### LAND USE APPLICATION FORM

File Number(s): GEO 18-01

Project Name: Green residence Number of Lots Proposed (If Applicable): 1 JUL16 3:23PM

**REQUIREMENTS TO DEVELOP PROPERTY AT THE ABOVE REFERENCED SITE**

**C3**

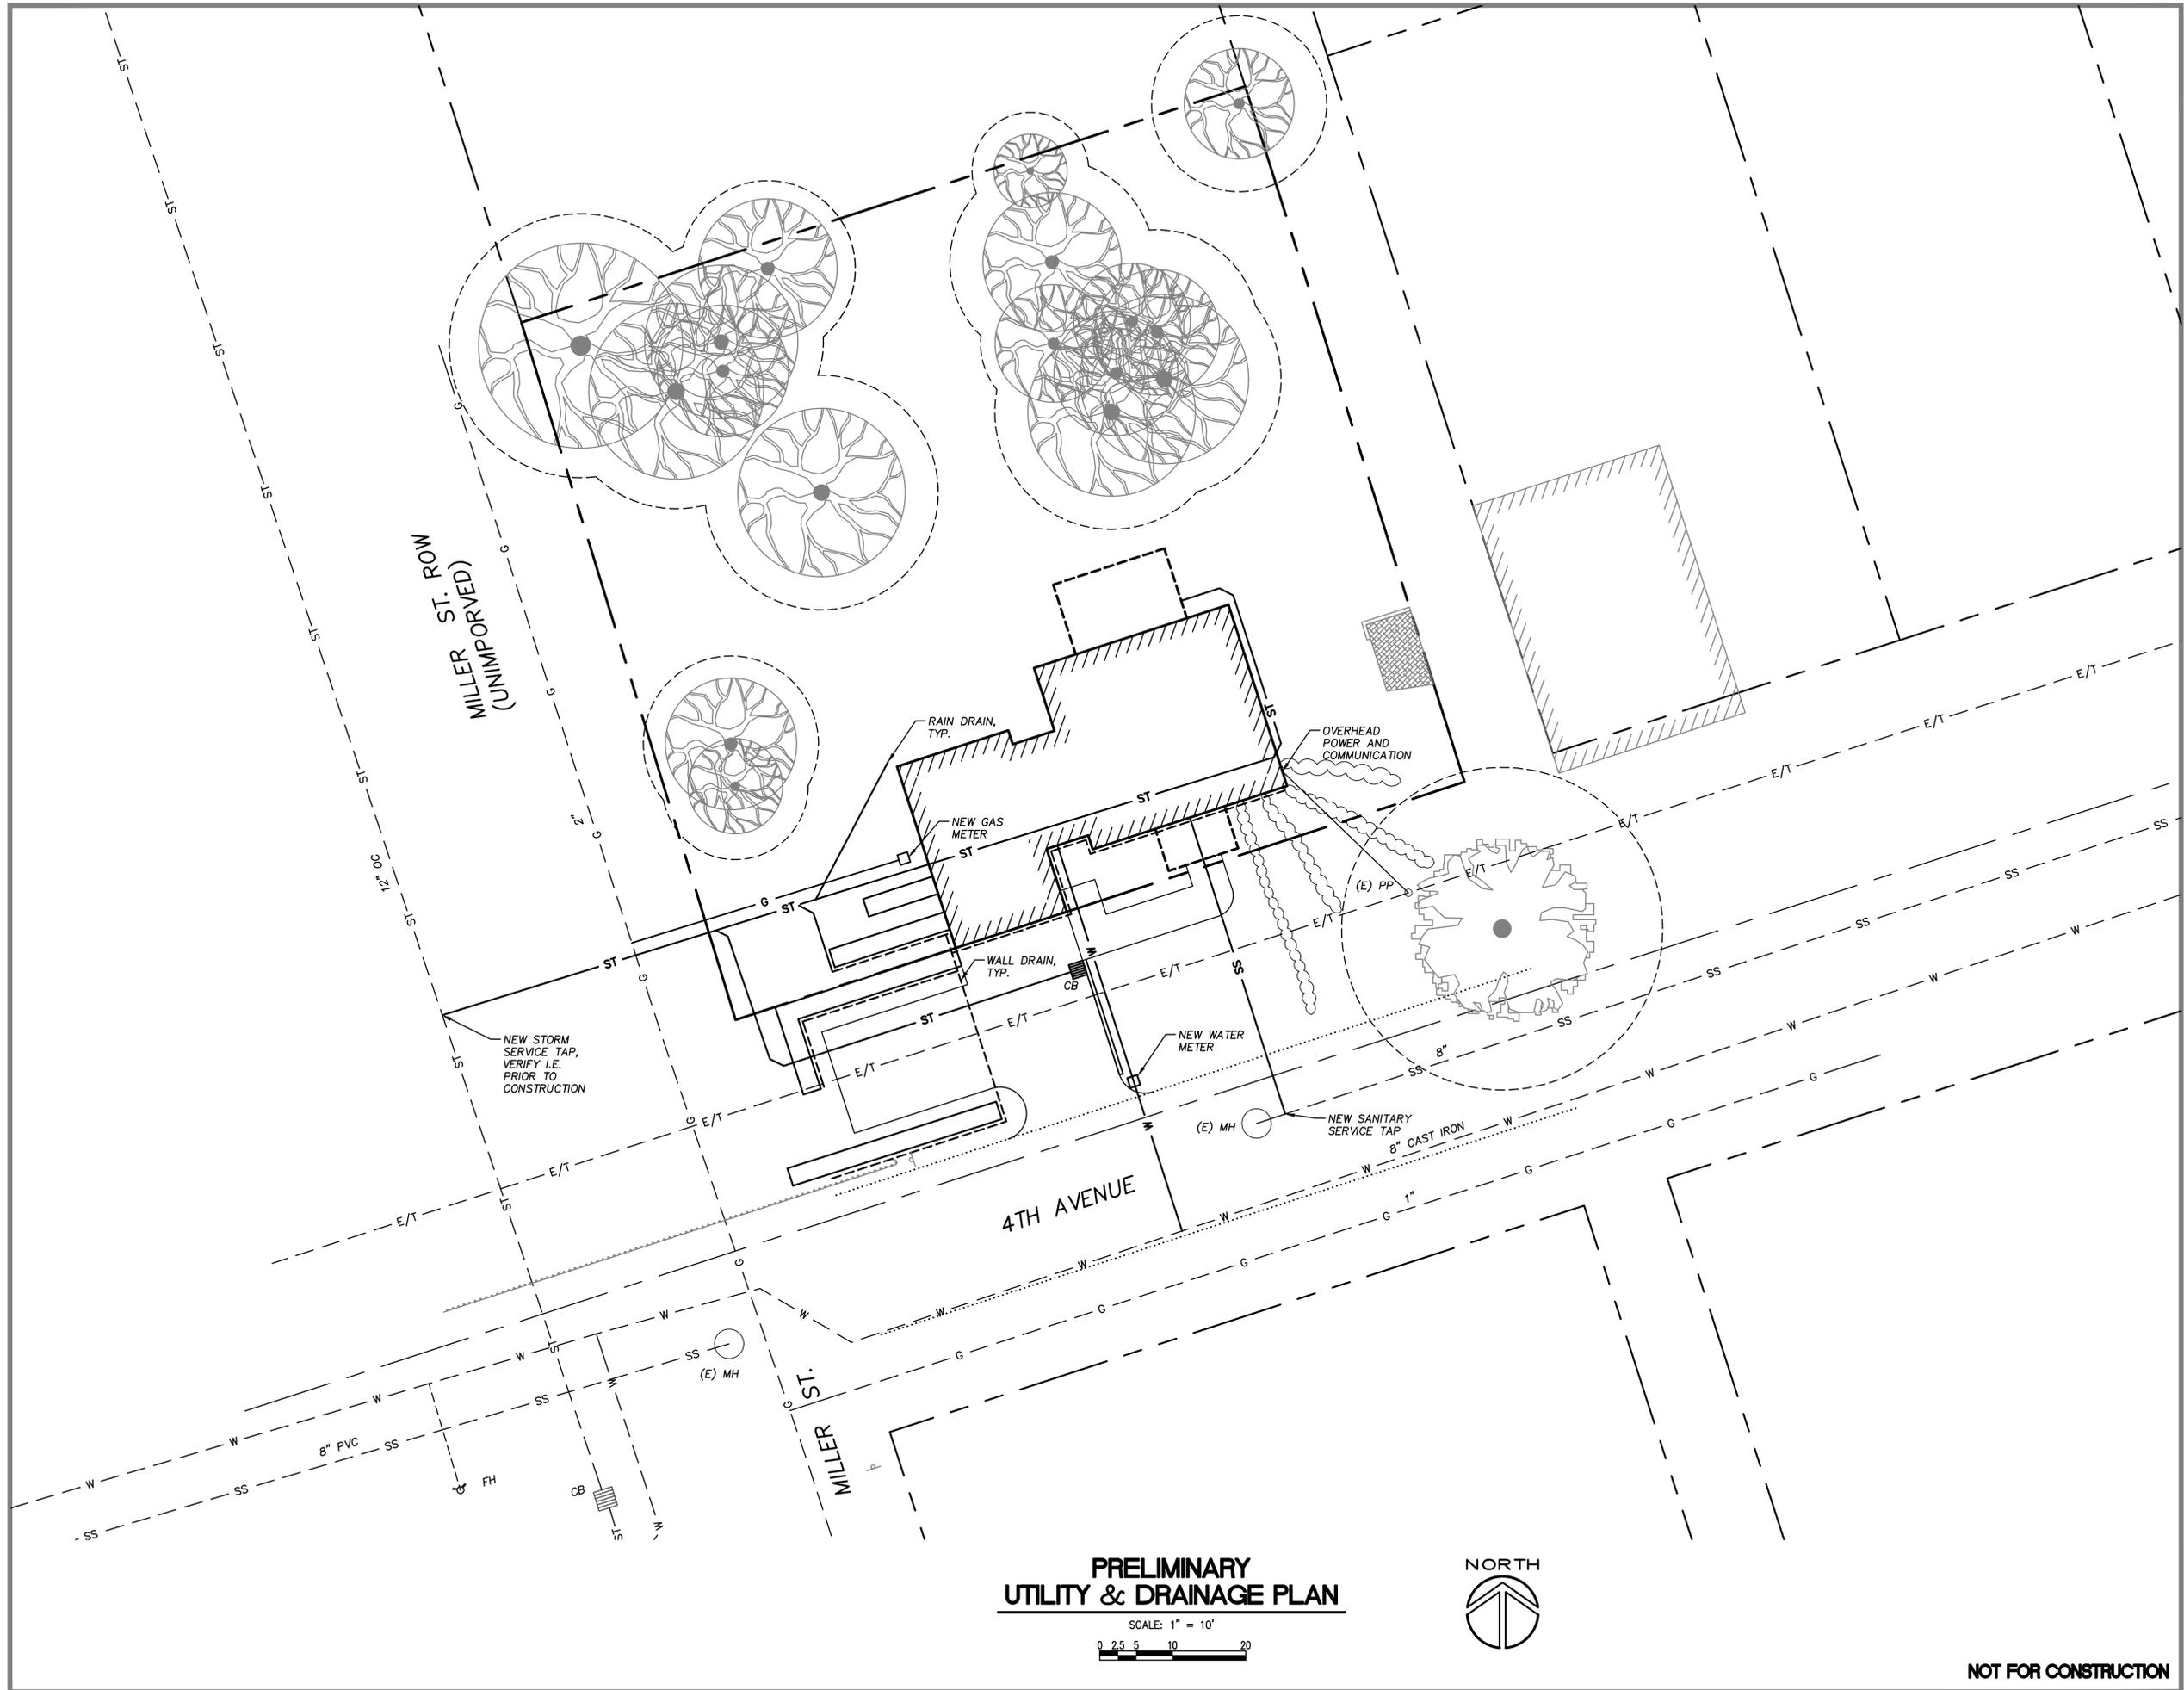
- Provide information regarding existing local drainage, impacts of the proposed permit activity on local drainage, and recommendations for mitigation to address adverse impacts.

See Sheet C3 Preliminary Utility & Drainage Plan for proposed drainage which includes collecting driveway and some street runoff, roof rain drains, retaining wall drains, and foundation and low point drains (not shown). It is the applicant's understanding that detention is not required in this location due to proximity to the Willamette River.

**Applicant's Response:** Not applicable, no roads are proposed. The drainage plan is simple, see Sheet C3-Prelim Utility & Drainage Plan.

**C4**

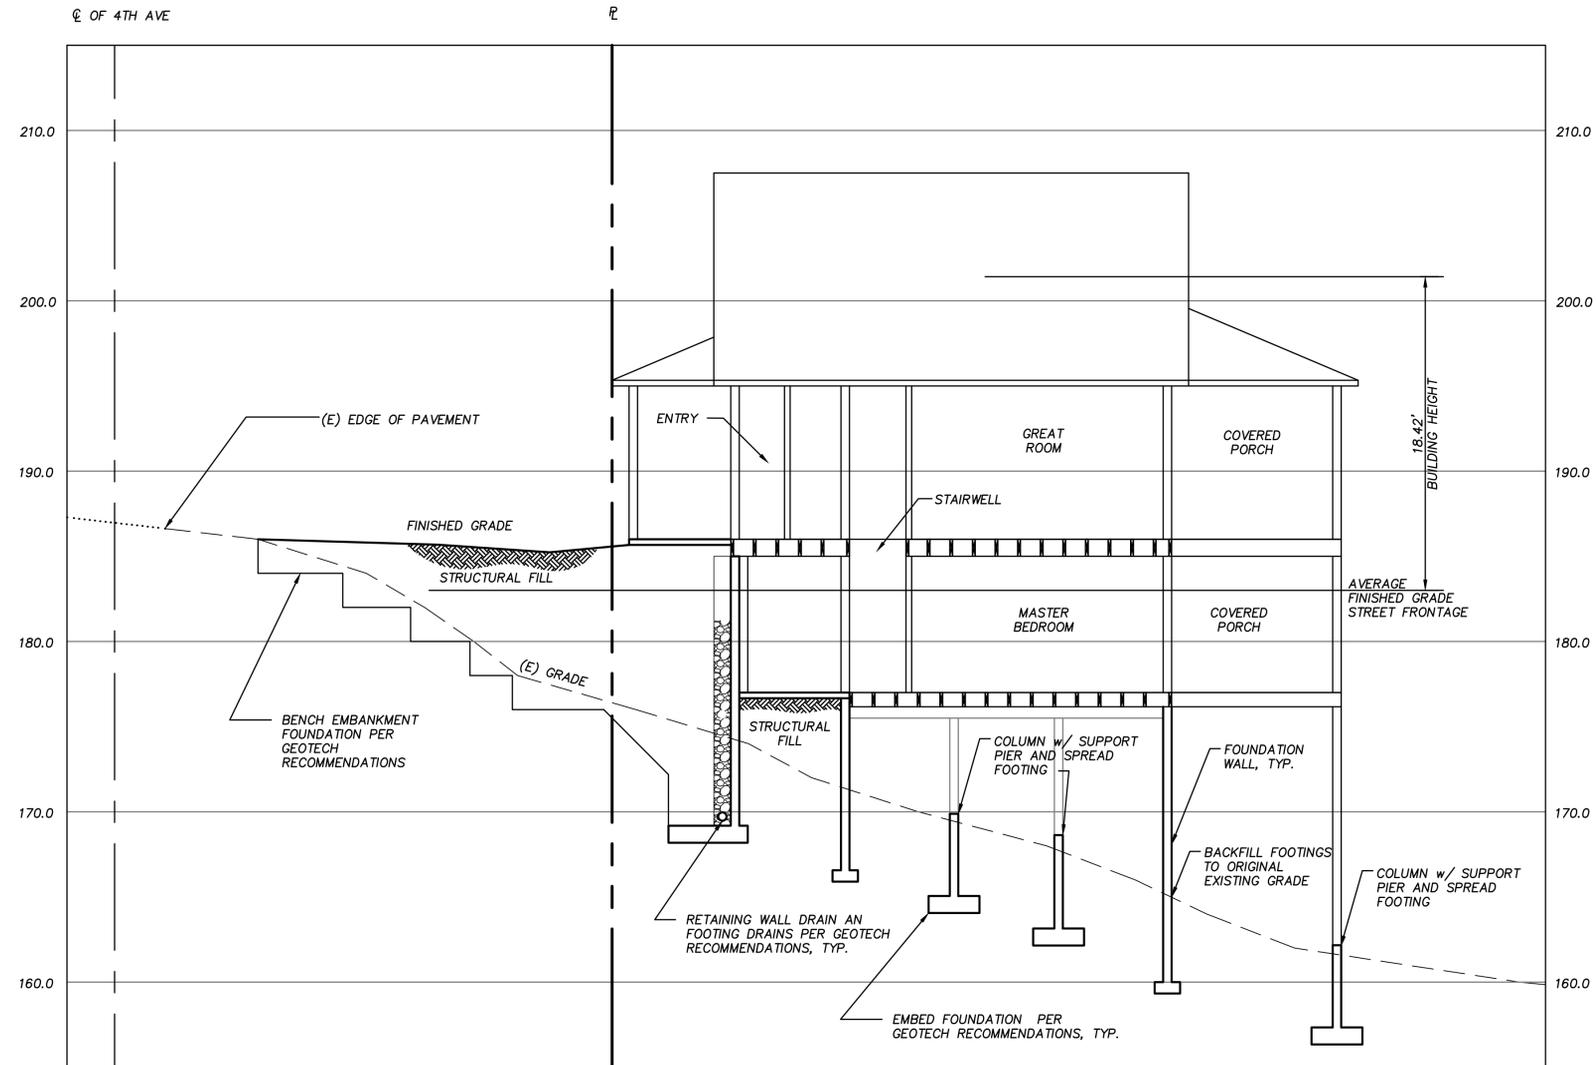
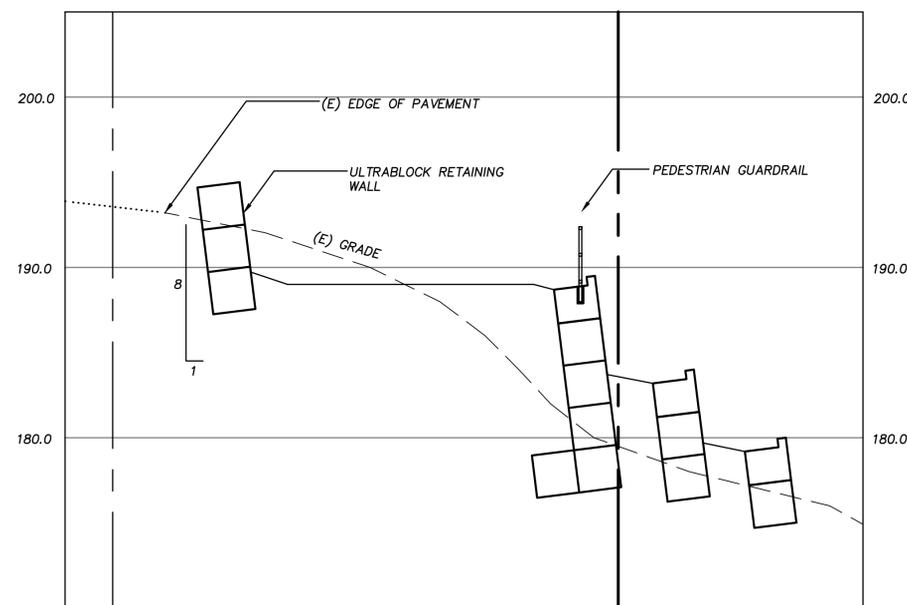
- Minimizing disturbance to the natural topography is high priority. The previous proposal for Taxlots 7300 and 7303 does not meet the intent of the code. House foundation elevations may need to be modified to accommodate the existing natural topography without the extensive cut and fill shown in the proposal. Cuts and fills must be minimized to the maximum extent practicable.

- g. Foundations shall either be deep foundations, or bearing 4'-6' deep to get below the organics layer. Sheet C4-Prelim Site sections illustrates the latter.

- 17.44.060.C Cuts and fills have been minimized to the maximum extent practical without elevating all structures onto piles. The "pile supported" concept would violate the preservation standards of the HRB. The house foundations shown on the sections are shown at the depth of embedment as required by the project geotechnical engineer as indicated by the horizontal lines at each footing on Sheet C4 dated 12/19/17. These foundations in the crawl space will be backfilled to the existing grade line shown. Additional notation is provided on Sheet C4 dated 5/14/18 to further describe the intent.
